## Technical Note TN-3390d-SR

### P25 Firmware v3.01.05

7 December 2023

This Technical Note applies to P25 cadence release R23.2.

- **JIRA-XPA-712: Add TCH images to Key Settings page**

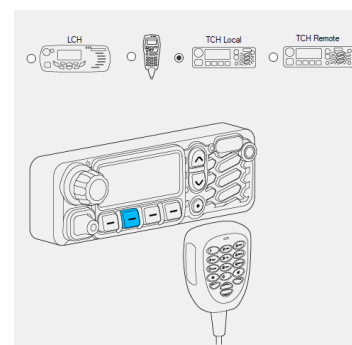
Updated the TM9400 and TM9800 Function Ctrl Settings page to include the display of the (TCH) color control heads and location of the relevant function keys for all head variants.
